# Staff Report

**Re:** TAG Row House Development  
PLNSUB2017-00723 – Planned Development  
PLNSUB2017-00964 – Preliminary Subdivision

## PLANNED DEVELOPMENT & PRELIMINARY SUBDIVISION

## **TAG Row House Development - 613 East 100 South**

**SITE PLAN & STREETScape CONTEXT**  
 SCALE: 1/16" = 1'-0"

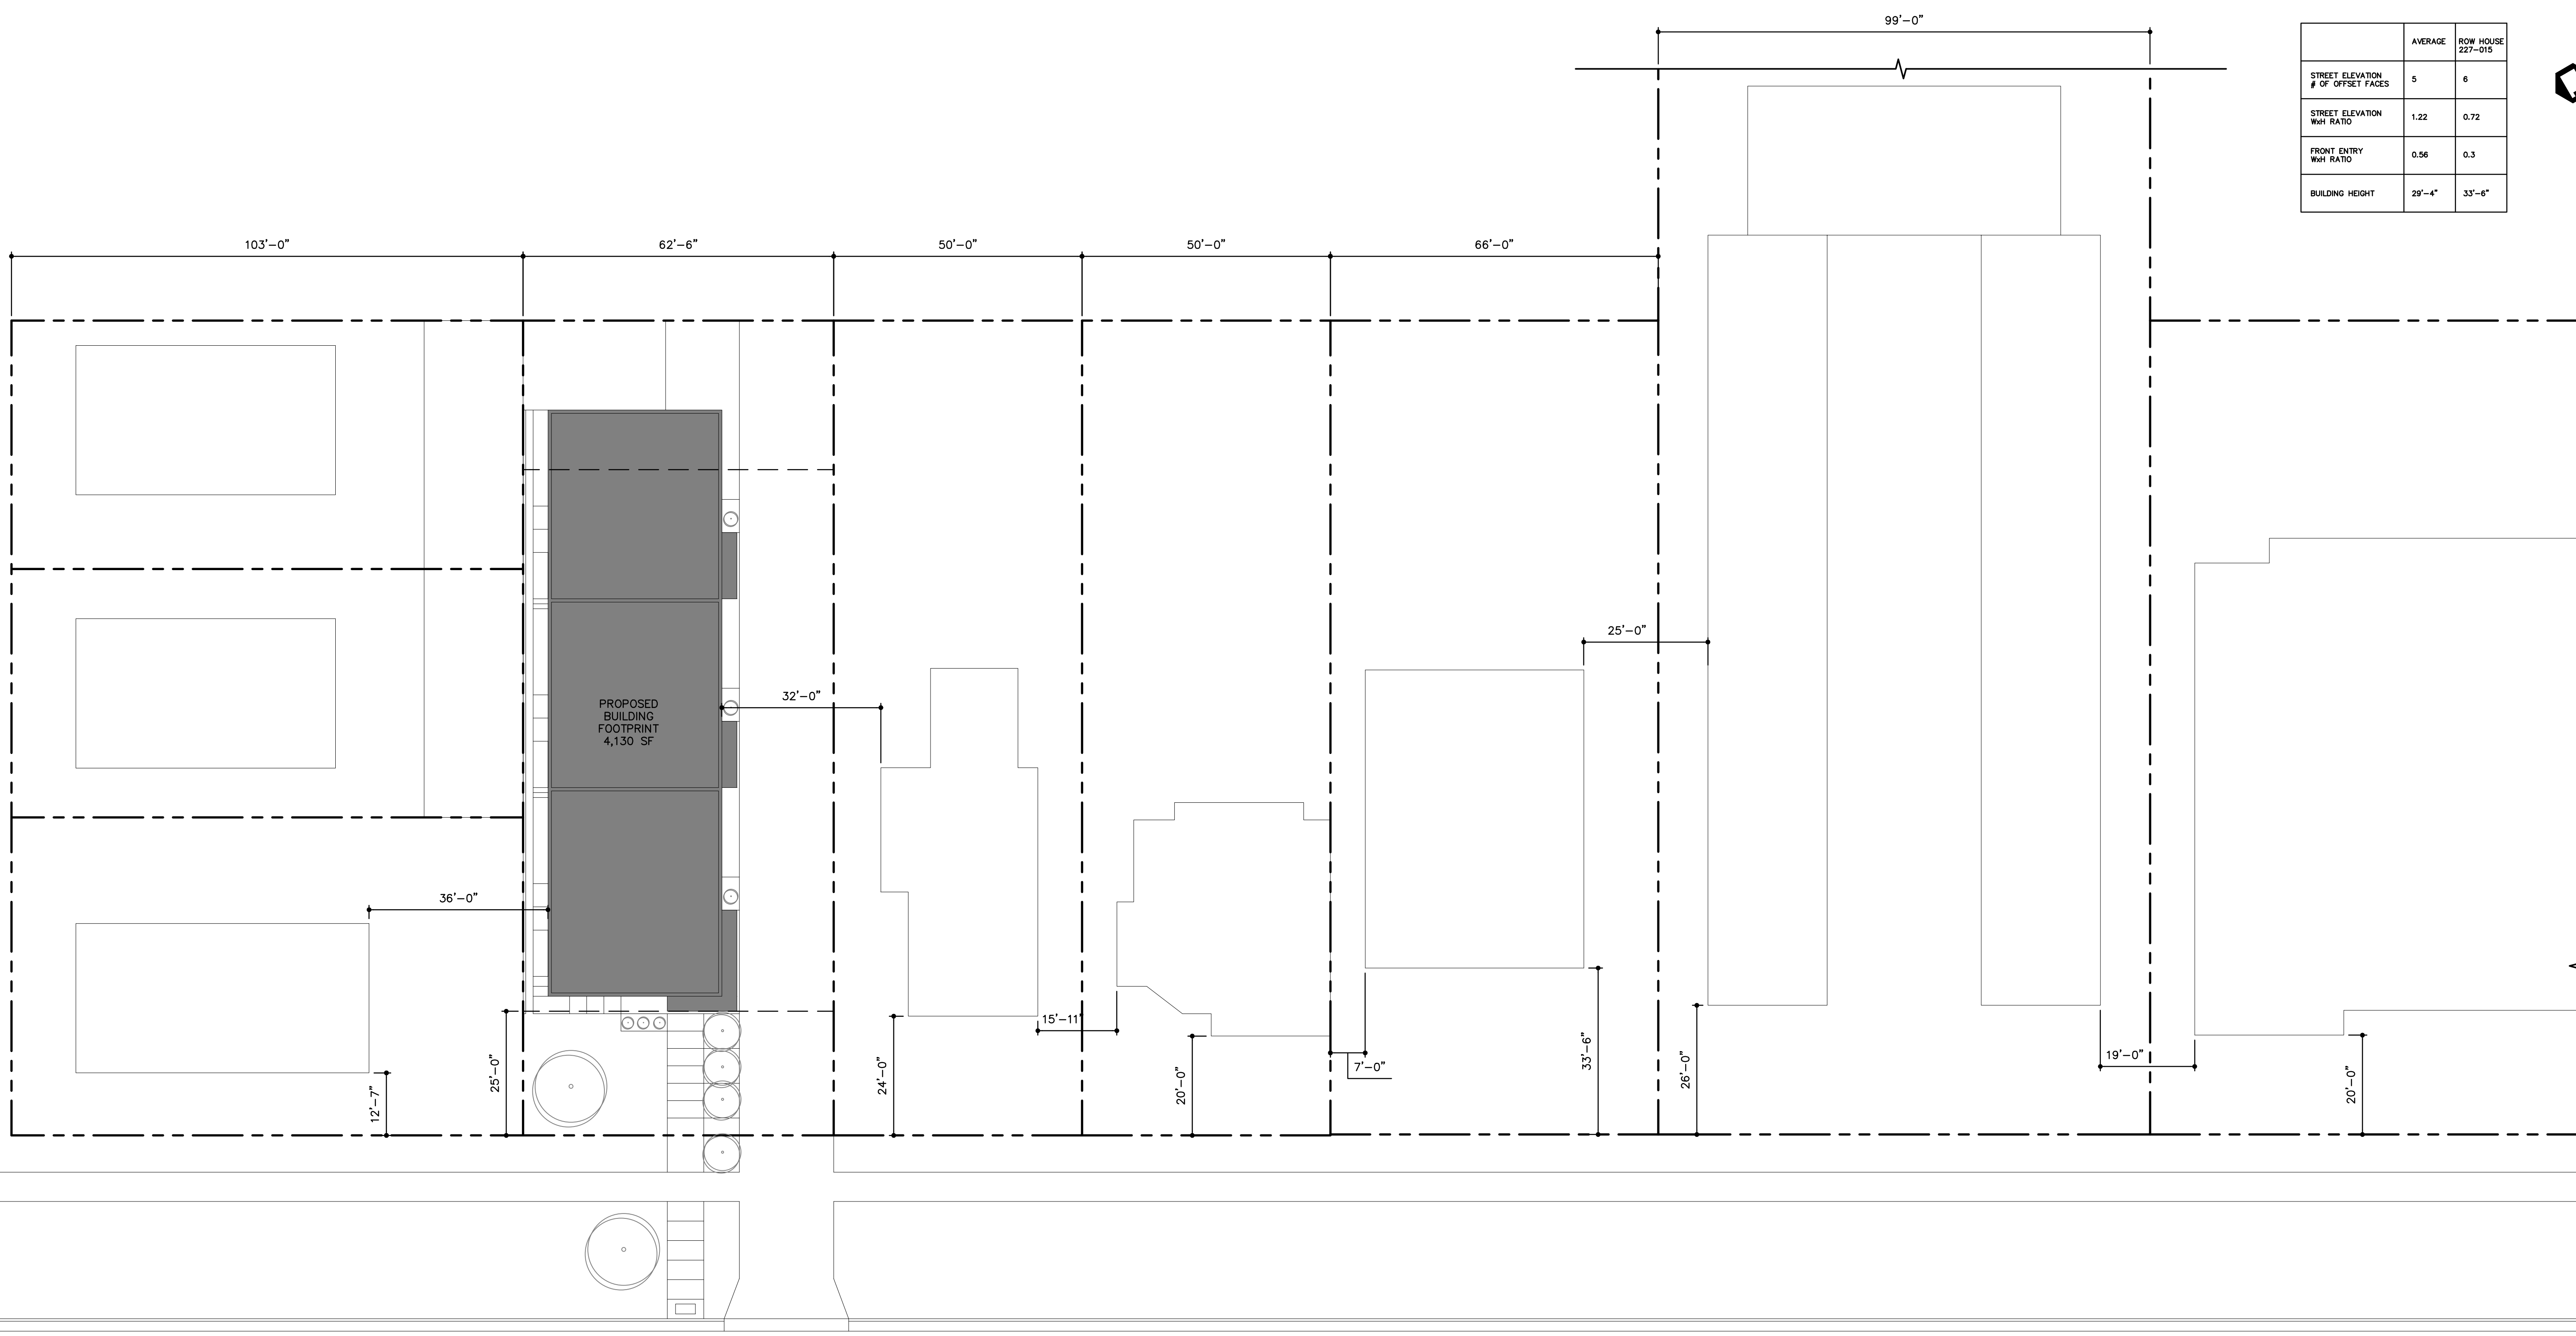
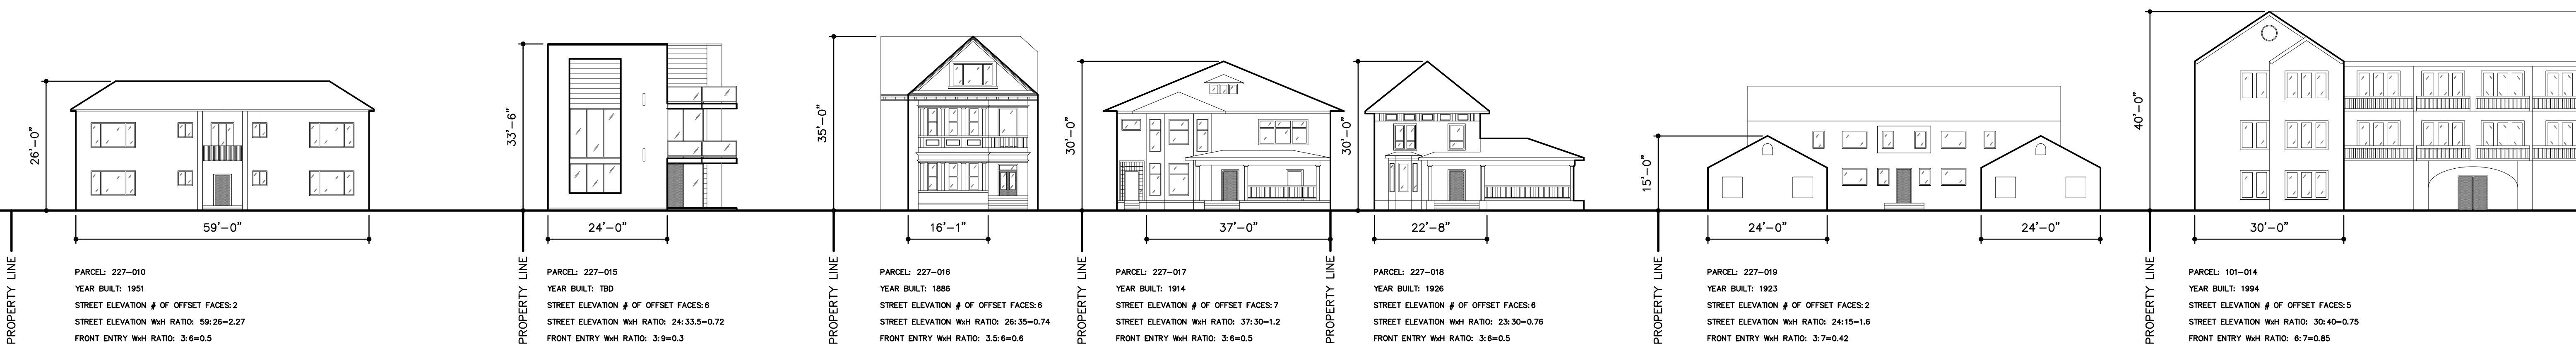
- The drawing requested has been completed and contains the required information. (Refer to A001)

**SITE PLAN**  
 SCALE: 1:80  
 A002

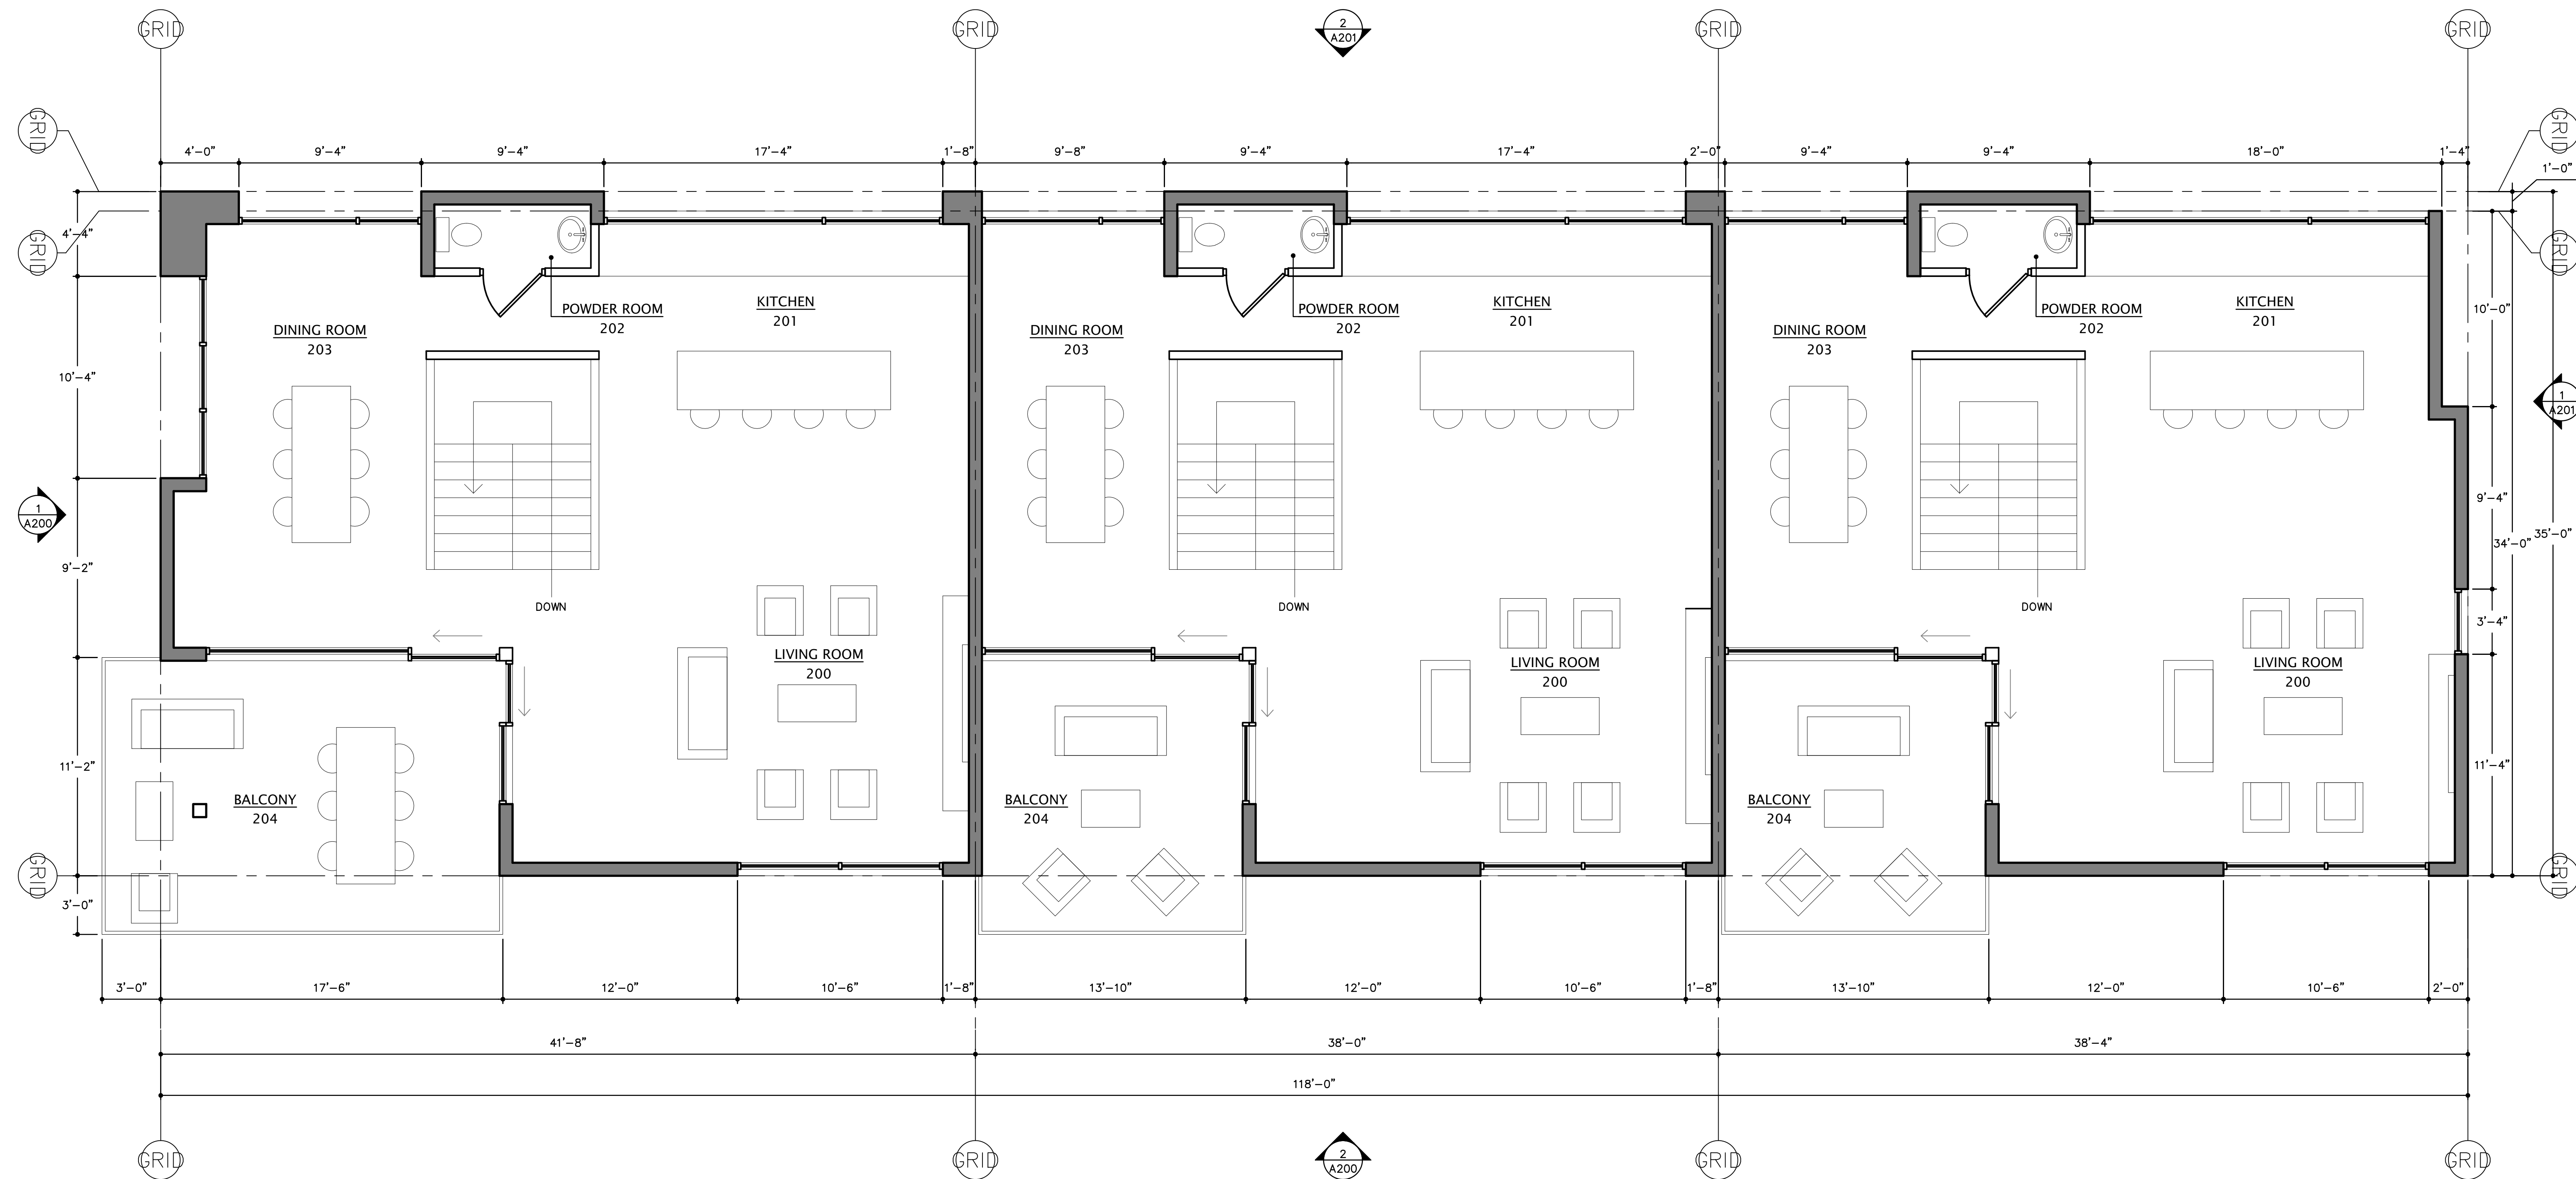
1. The building has been pushed back so that the balconies are meeting the front yard setback. (Refer to sheet A002.)
2. The current driveway is 19' feet wide. To accommodate Section 21A.24.010(H) landscaping is being provided along the east property line (Image B). We are coordinating with the neighbor to the east (Parcel 227-016) to allow for a series of shrubs to be planted along their side of the property which will provide adequate landscaping and a natural barrier between the two neighboring properties. (Refer to sheet A002.)
3. The AC units are not located closer than 4 feet to the property line. They will be enclosed in a dedicated mechanical closet and they will be completely out of site. (Refer to mechanical equipment cut sheet, A100 - "Mechanical Closet #105")

- Landscaping has been installed along the south, east & west side of the property. (Refer to A002)

- The back patios have been dimensioned. The intent of the space is to serve as an entry path and landing for the second entry to the home. The patios and steps along the west elevation will be built of concrete. The steps and their respective elevations have been indicated on the site plan. Their purpose is to create a path to the home's second entry as there exists a natural change in grade. We have designed the site work so as to mitigate impact on the existing topography. (Refer to A002).

- The location of the trash & recycling receptacles has been indicated on the site plan. The receptacles will be screened as described on the site plan. (Refer to A002)

- The size and dimensions of the balconies' footprints has been labeled. The balconies protrude 3'-0" from the building and the south face of the balcony meet the front yard setback. (Refer to A002, A100, A101 & A102) As discussed during our review meeting a balcony detail will not be required at this time.

**SOUTH ELEVATION** 1  
 SCALE: 3/16" = 1'-0" A200

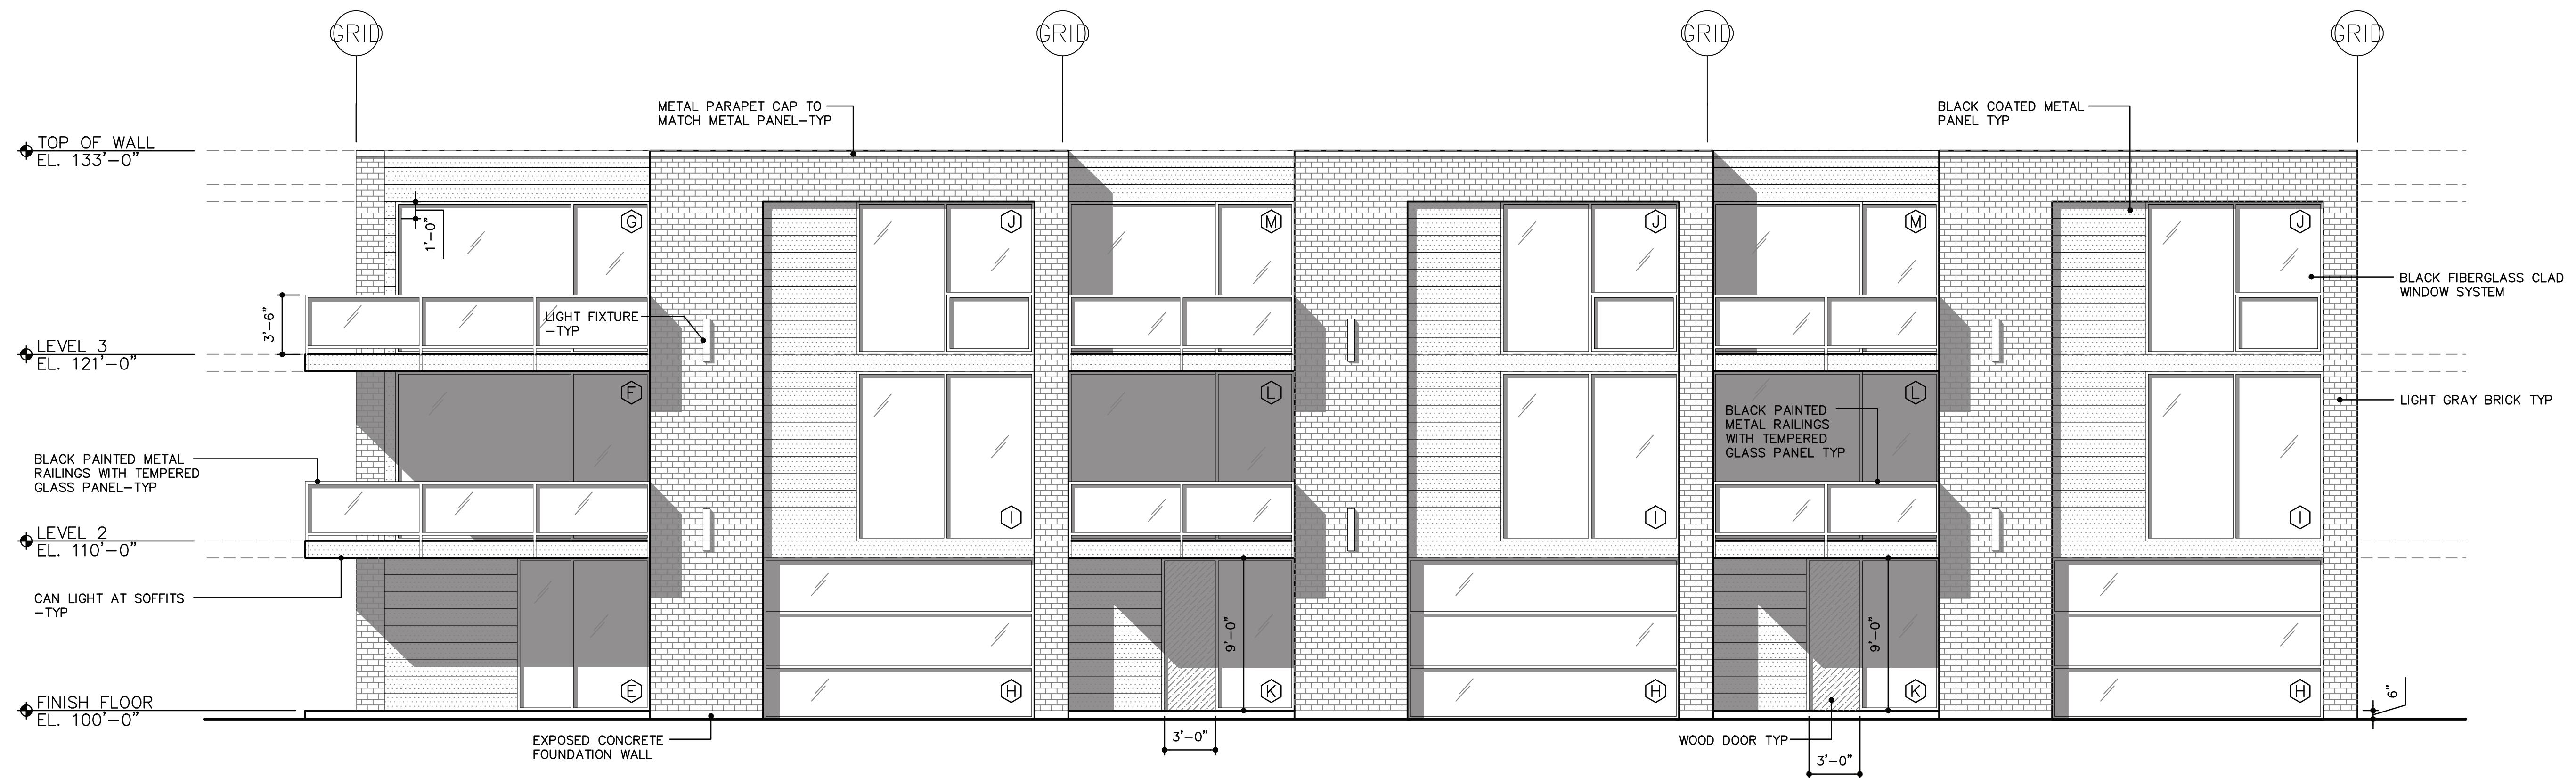
- The width of the metal panels has been dimensioned on the elevation drawings. the panels will be 1'-0" in width. (Refer to A200 & A201)

- The front and back doors will be made of stained plain sawn cherry wood. The door panels will be flat with a smooth satin finish. The doors have been dimensioned on the elevations. The front doors will be 3'-0" x 9'-0" and the doors on the west elevation will be 3'-0" x 7'-0". (Refer to A200 & A201)

- Two types of light fixtures will be used on the exterior of the building. A wall mounted fixture and a recessed can fixture will be located as indicated on the elevation drawings. (Refer to exterior light fixture cut sheets, A200 & A201)
